Development Review (Minor) Staff Approval

331-SA-2022#2
Whole Foods at Miller
Plaza

RE: **331-SA-2022#2**
Whole Foods at Miller Plaza
97L20 (Key Code)

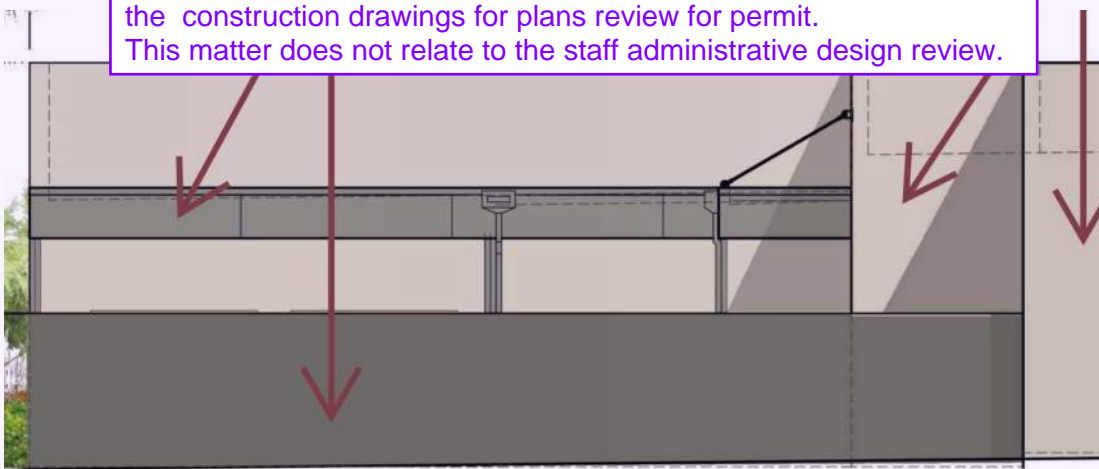
12. The canopy lighting fixture specs are missing from the submittal package. Tango 20 Square Pendant Downlights and Sedan 6 Wide Beam Distribution lights were originally approved under case 331-SA-2022. Please provide fixture specifications for proposed lighting under new shade canopies.

hayes inc. will attach approved lights.

LANDSCAPE PLAN

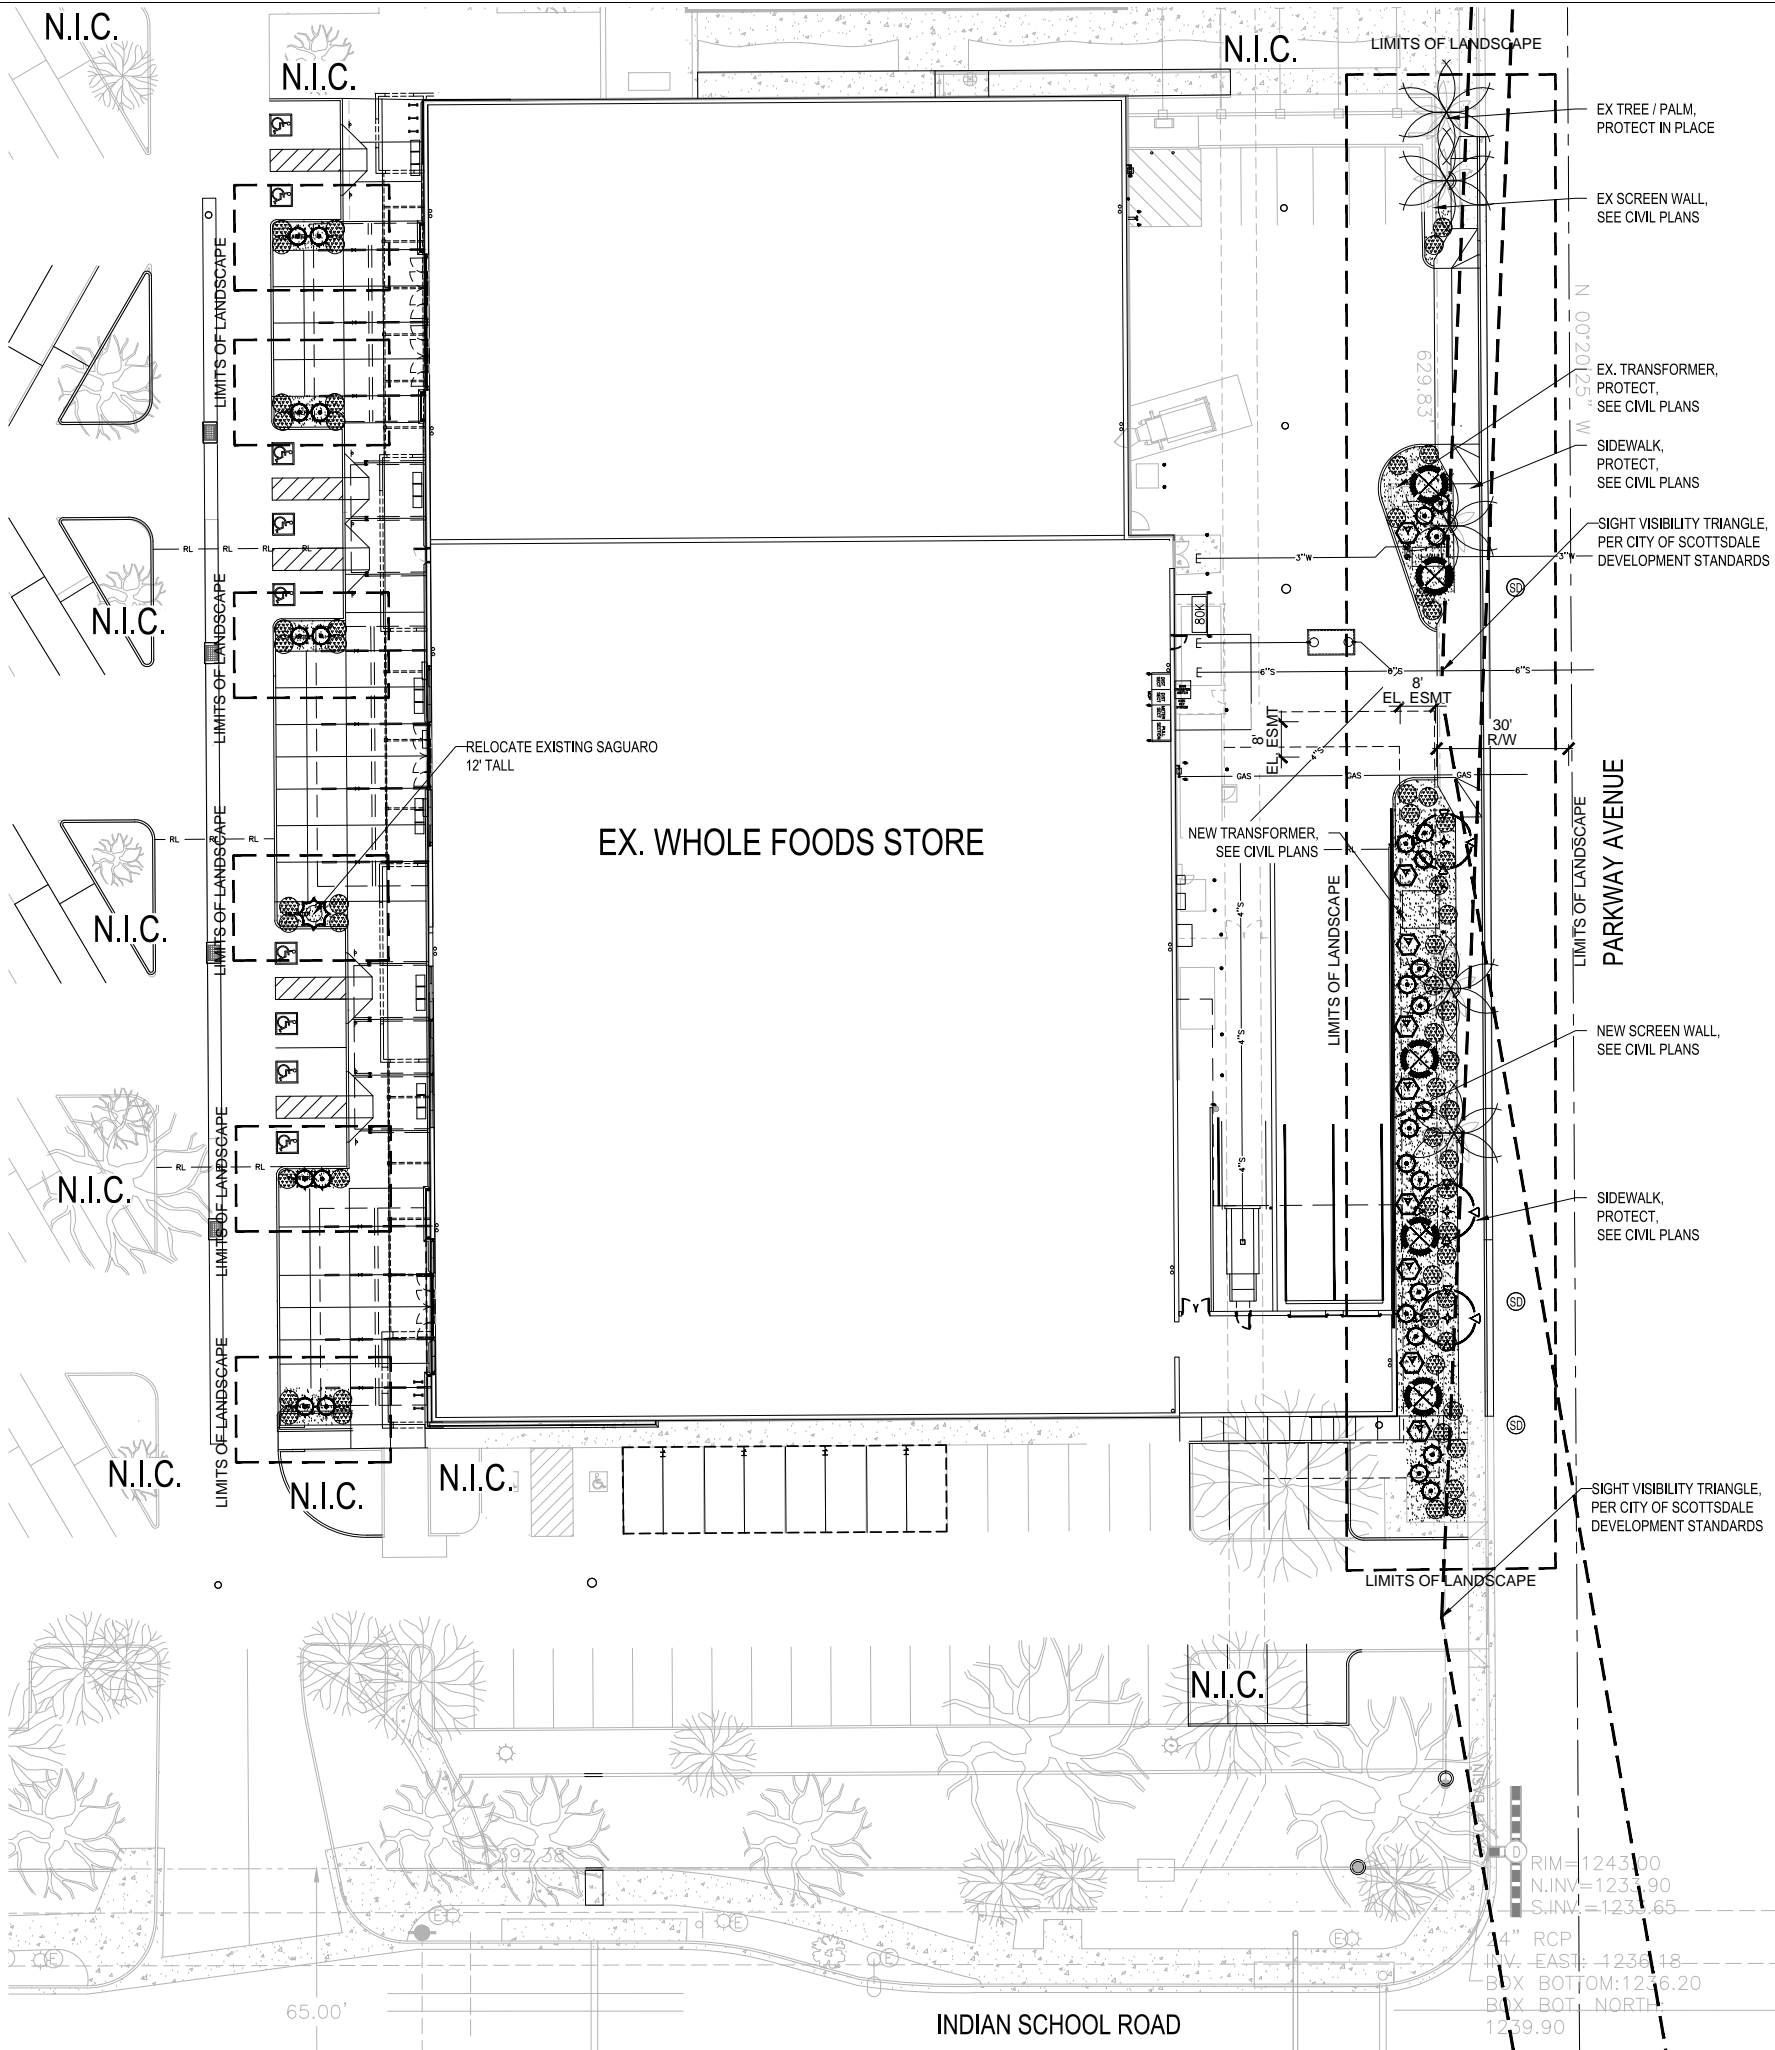
10. The provided site plan indicates that the existing trees along N. Parkway Avenue are to be removed, however, the landscape plan indicates that the trees will be protected. The submitted plans do not appear to be coordinated closely with the submittal packet. The trees on Parkway Ave. are to remain

11. The proposed groundcover "Coral Fountain" does not appear to be a ADWR approved low-water usage plant. The prior approval (331-SA-2022) proposed Lantanas as groundcover consistent with

the ADWR list. Please revise consistent with the requirements of Chapter 49 – Article VII Sec. 49-246 and the prior landscaping approval under case #: 331-SA-2022.

Please defer comments to the phase when architects are submitting the construction drawings for plans review for permit.
This matter does not relate to the staff administrative design review.

Please defer comments to the phase when architects are submitting the construction drawings for plans review for permit. This matter does not relate to the staff administrative design review.
